# UNITED STATES PATENT AND TRADEMARK OFFICE

10/531,104

<b>Office Action Summary</b>	<b>Application No.</b> 10/531,104	<b>Applicant(s)</b> LAIHO, KIMMO	
	<b>Examiner</b> Khanh Dang	<b>Art Unit</b> 2111

## **DETAILED ACTION**

Figure 3

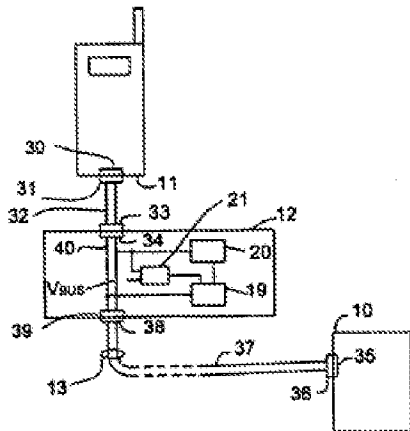
by the comparator of the presence of the host externally connected to the bus (at the outset, Applicants' Fig. 3 is reproduced below for comparison.

As shown in Applicants' Fig. 3, element 12 is the so-called "device operable as a host device," element 34 is the "first USB port," element 39 is the "second USB port," element 19 is the "host module," element 21 is a "comparator," and element 10 is the so-called "host externally connected to the bus" (note that all USB ports/connectors including Applicants' USB ports 34 and 39 include Vbus, GND, D+, and D-). The Vbus line of the USB bus is connected to "comparator" 21 while the rest of USB bus lines are connected to the "host module" 19. As shown in Fig. 3 of Oguma, which is reproduced below for ease of reference and comparison, Oguma discloses the so-called "device operable as a host" including a USB bus comprising Vbus, GND, D+, and D-. The device further comprises a first upstream USB port or "first port" having Vbus, GND, D+ and D-, connected directly to the USB bus; and a second USB downstream port or "second port" having Vbus, GND, D+ and D-, connected directly to the downstream of to

Fig. 3

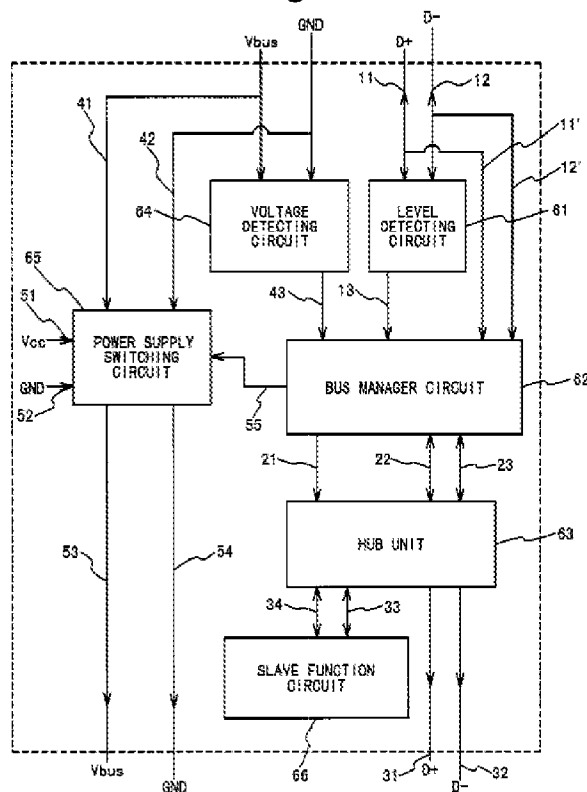
the same USB bus running from the first upstream USB port to the second downstream USB port. The device as shown in Fig. 3 of Oguma also shows the so-called "host module" or bus manager circuit 62 connected directly to the same USB bus; and the "comparator" or voltage circuit 64 detecting coupled to the same USB bus to detect the presence of a host externally connected to the USB bus. A voltage detecting circuit basically comprises a voltage comparator for comprising a supply voltage with a reference voltage (VREF) to detect a change in voltage or a difference between supply voltage and reference voltage. Further, as noted above, a USB bus comprises Vbus, GND, D+, and D-. It is also important to note that Applicants' Fig. 3 shows a Vbus line, and other lines are grouped together as line 40. See at least column 2, lines 39-57, column 4, line 65 to column 6, line 17).

Further, as shown in Fig. 3 of Oguma above, the Vbus and GND of the upstream USB port are connected directly to the corresponding Vbus and GND of the downstream USB port. Element 65 in Fig. 3 of Oguma is simply a power supply switching circuit to supply direct power from different USB power sources. To receive power directly from the Vbus and GND of the upstream USB port, the Vbus and GND of the downstream USB port must be connected directly to the Vbus and GND of the upstream USB port. In addition, as shown in Fig. 3, the D+ and D- of the upstream USB port is connected the D+ and D- of the downstream USB port via the bus manager circuit 62 and USB Hub 63. However, in column 4, lines 18-22, Oguma also discloses that the "bus manager circuit 62 passes through the signal [D+ and D-] between host

Thus, the difference between the claim subject matter and that of Oguma is the direct connection between the D+ and D- lines of the upstream USB port and the D+ and D- of the downstream USB port. As shown in Fig. 3 of Oguma, the D+ and D- lines of the upstream USB port and the D+ and D- of the downstream USB port are connected via a USB Hub 63.

Thus, it would have been obvious to one of ordinary skill in the art at the time the invention was made not to use the USB Hub in Oguma, since the purpose of using a USB Hub is simply expanding the number of downstream USB ports that the USB Host can communicate with, as taught by Hsu, and thus, the use of the USB Hub is clearly optional. When the USB Hub 63 is not employed in Fig. 3 of Oguma, it is clear that the D+ and D- lines of the upstream USB port and the D+ and D- lines of the downstream USB port are directly connected; and as a result, the USB bus passes USB D+ and D-
